4th December 2015

Reference: 15514.01FA

**TRAFFIC ENGINEERING REVIEW
RESIDENTIAL PLANNING PROPOSAL
MILTON STREET, ASHBURY NSW**

ANNEXURE A: ROUNDABOUT CONCEPT PLAN

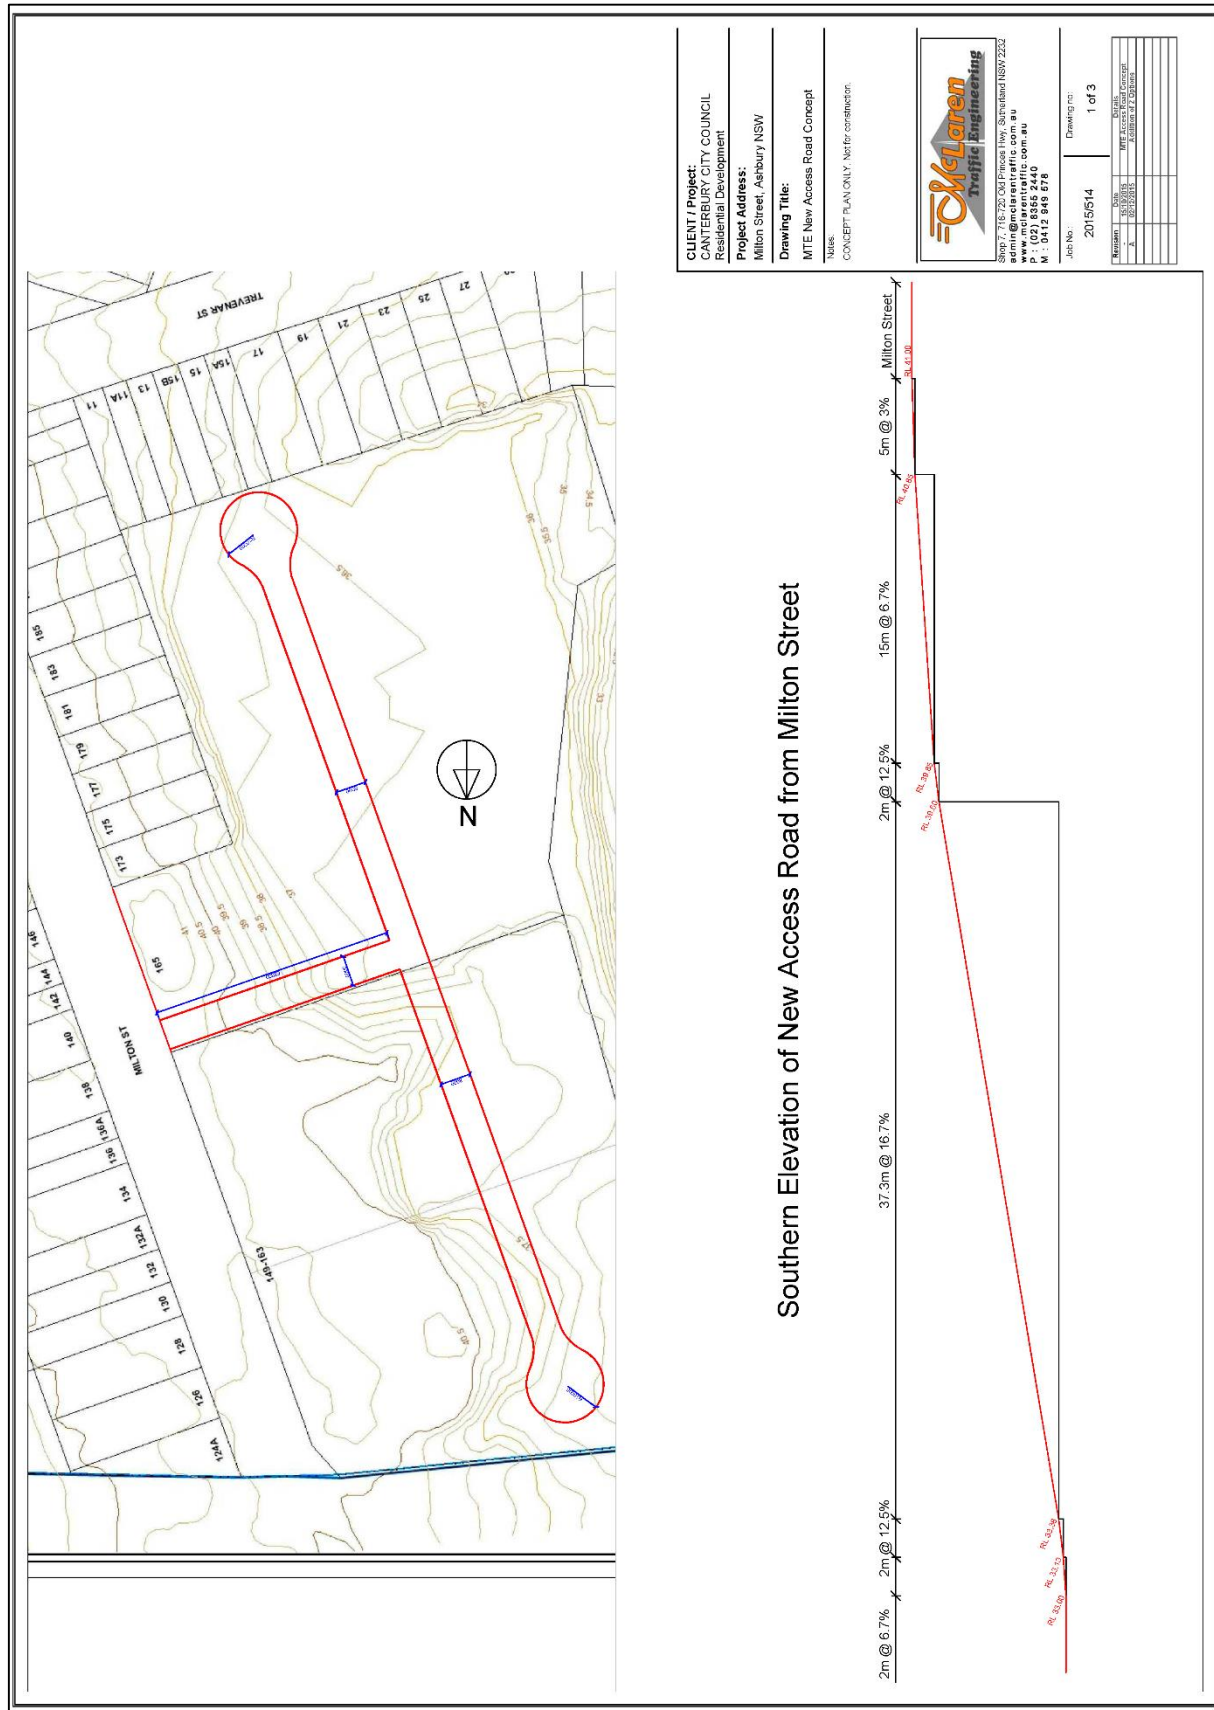
To reduce the number of vehicle access points to the site along Milton Street, *McLaren Traffic Engineering* has prepared a roundabout concept (**Annexure A**) which is recommended as the preferred option for a single access road into the site. It should be noted that the location, whether on the northern or southern lot, and dimensions of the concept drawing are subject to final design by Council. The roundabout will ensure traffic flow efficiency is maintained along Milton Street with the increased traffic load and will remove the need to provide multiple driveways along Milton Street, as well as lessening to the greatest extent possible the loss of on-street parking. The proposed development yield and existing volumes along Milton Street do not warrant the need for traffic signals, however a roundabout can accommodate the increased traffic volumes and will improve the safety of right turning vehicles.

The concept plan of the roundabout shown in **Annexure A** has been based off dimensions of similar roundabouts within Ashbury and is adequate for Heavy Rigid Vehicle (HRV) access.

ANNEXURE B: INTERNAL ACCESS ROAD CONCEPT PLAN
(SHEET 1 OF 3)

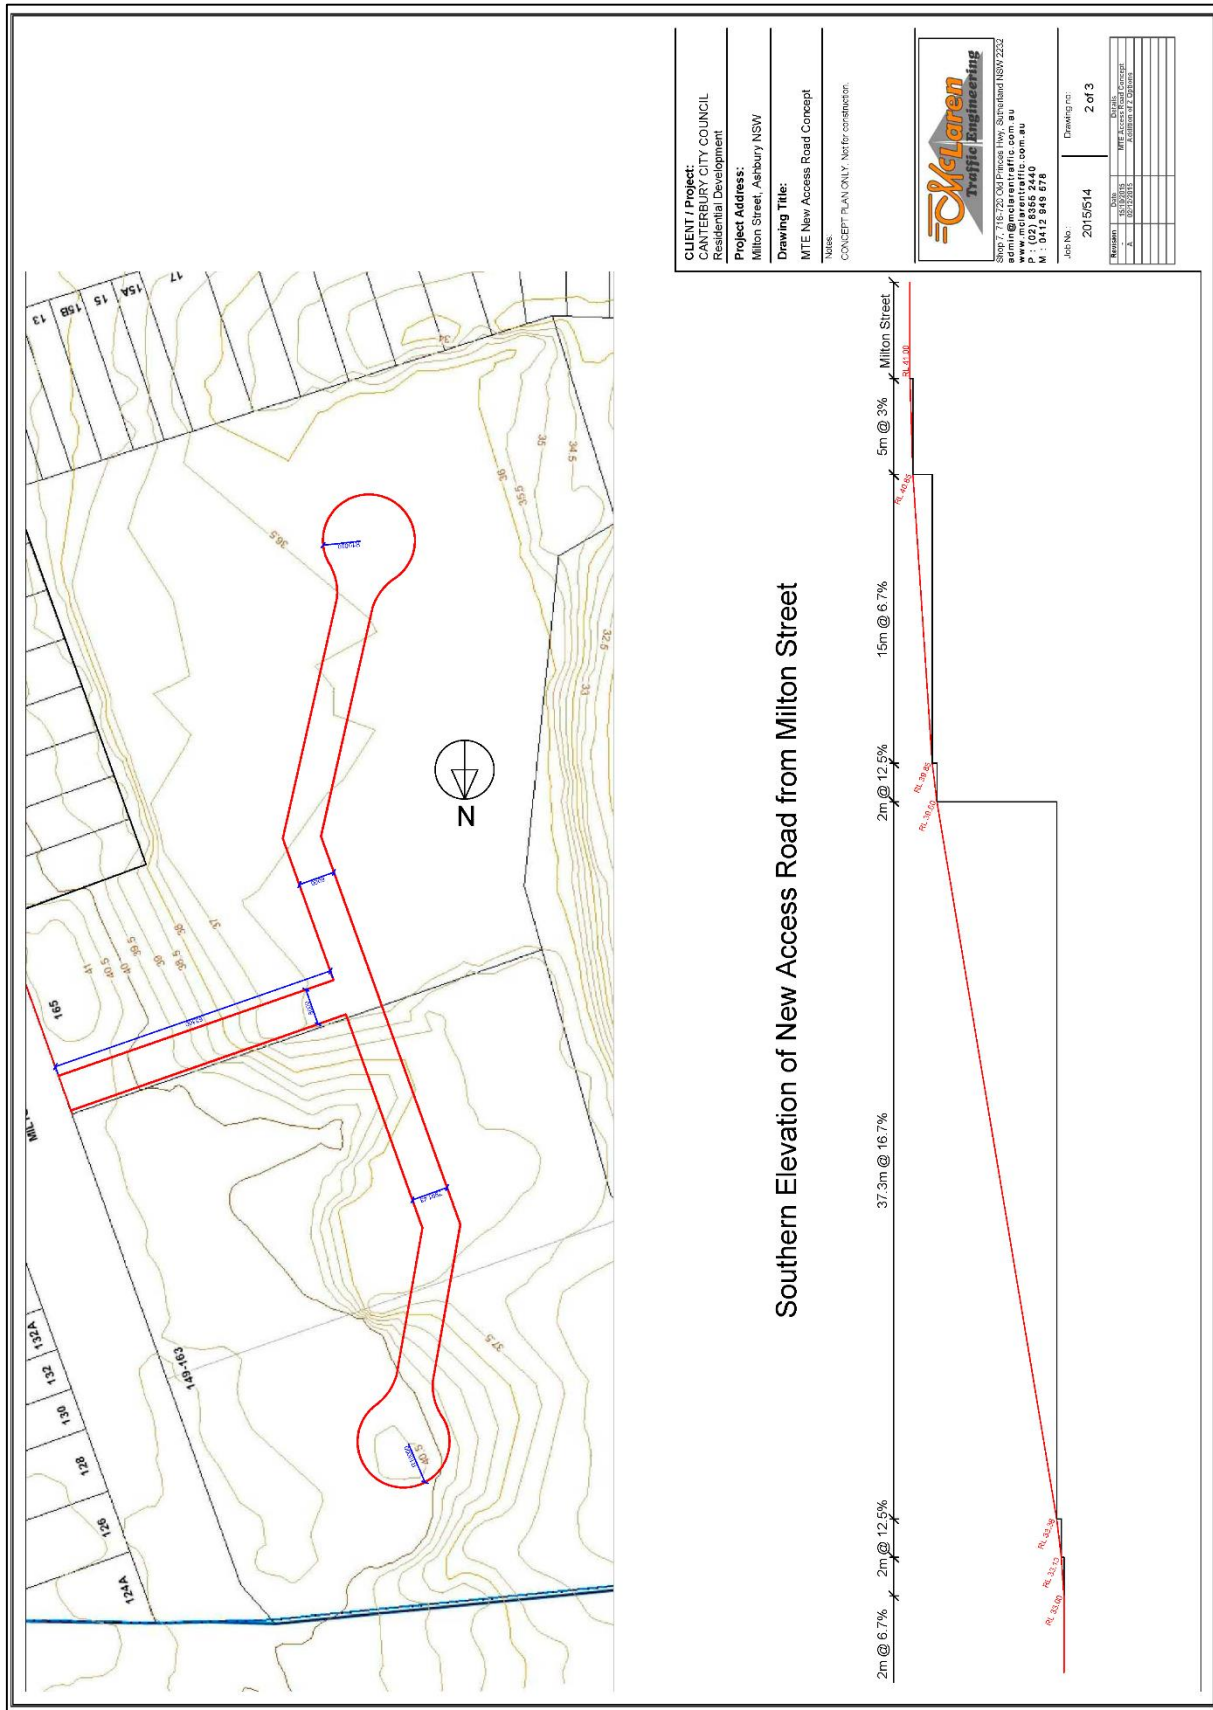
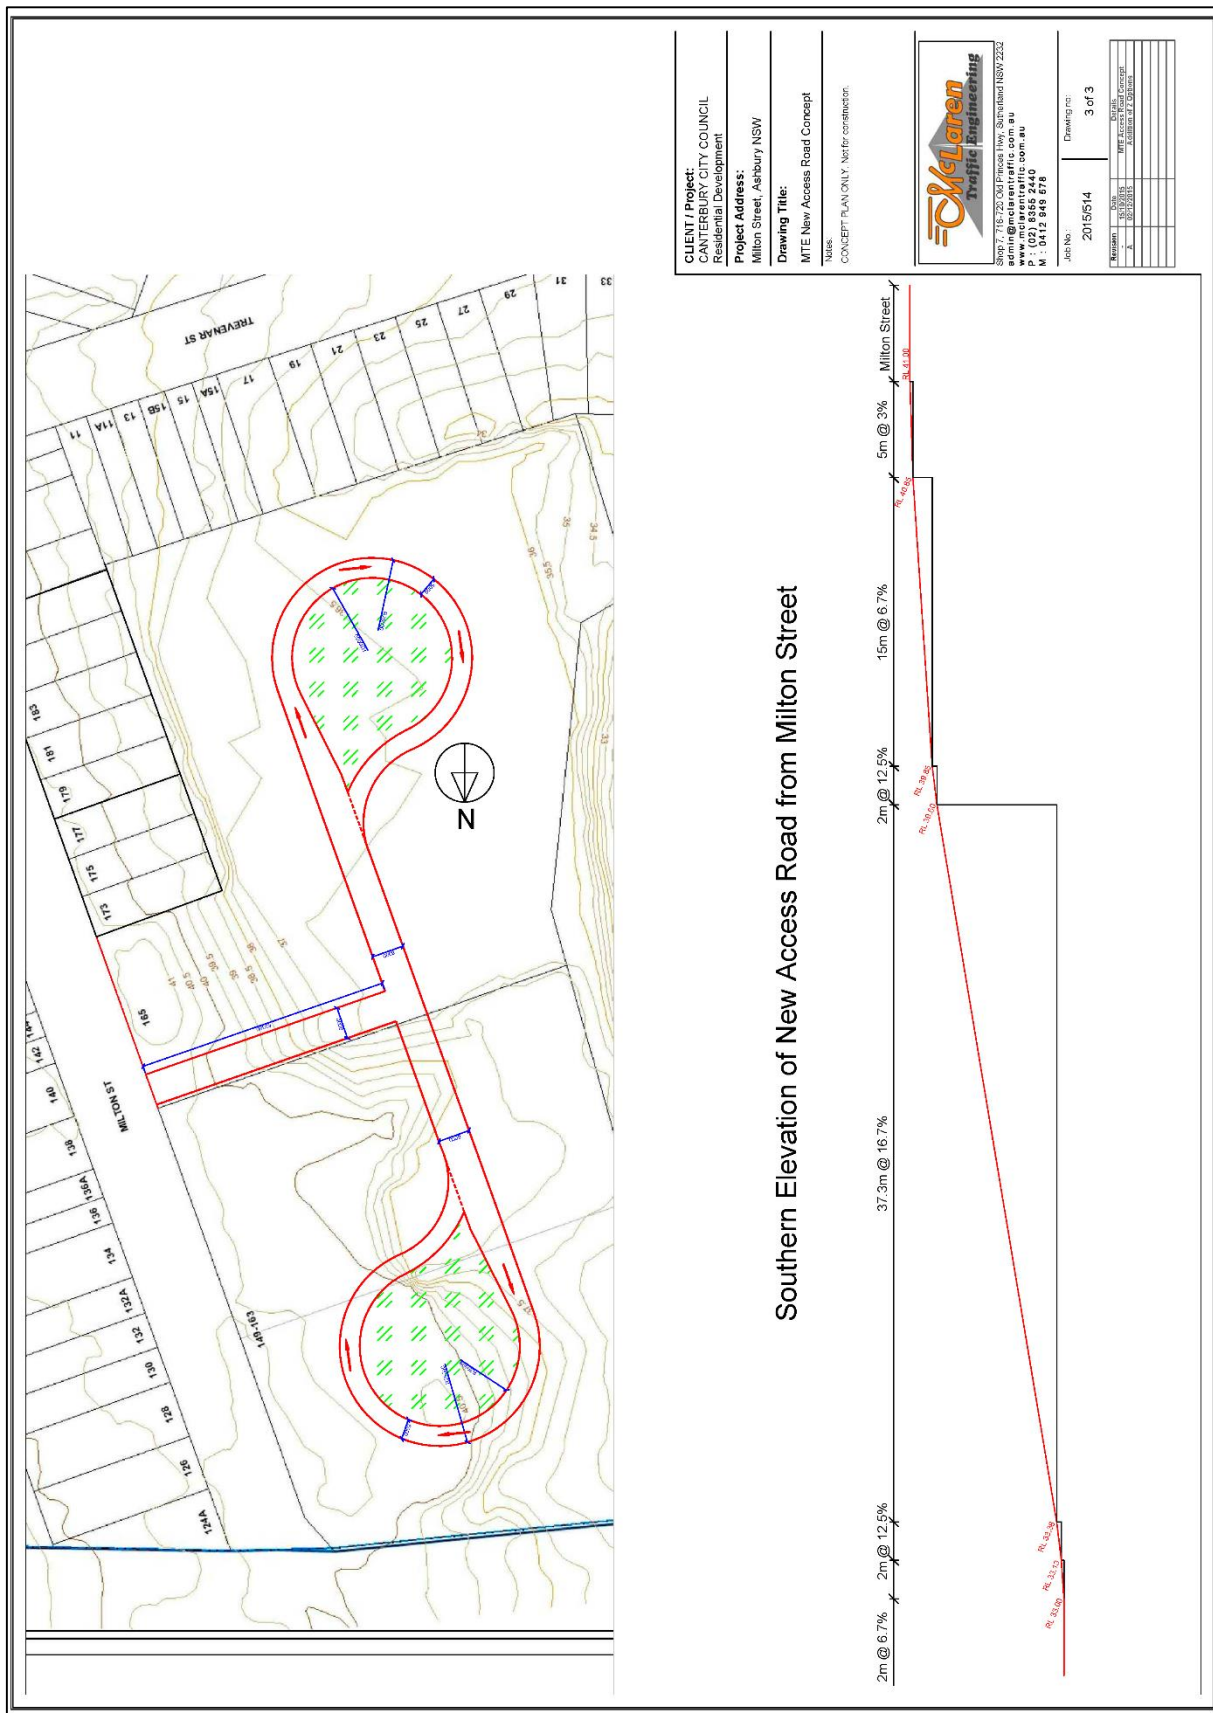
To provide equal access to both the northern and southern portions of the site, an internal access road layout in the form of a “T-road” from the roundabout is shown in **Annexure B**, consistent with Council’s vision for the site. The access roads will measure 8.0m wide with 10m radius turning bulbs or 20m diameter, 5m wide one-way loop roads on either end of the “T-road”, adequate for a Heavy Rigid Vehicle to circulate.

The internal access road concept plans shown in **Annexure B** provide an elevation plan of the east-west access road connecting directly to Milton Street with all grades compliant with the NSW emergency vehicles access guidelines.
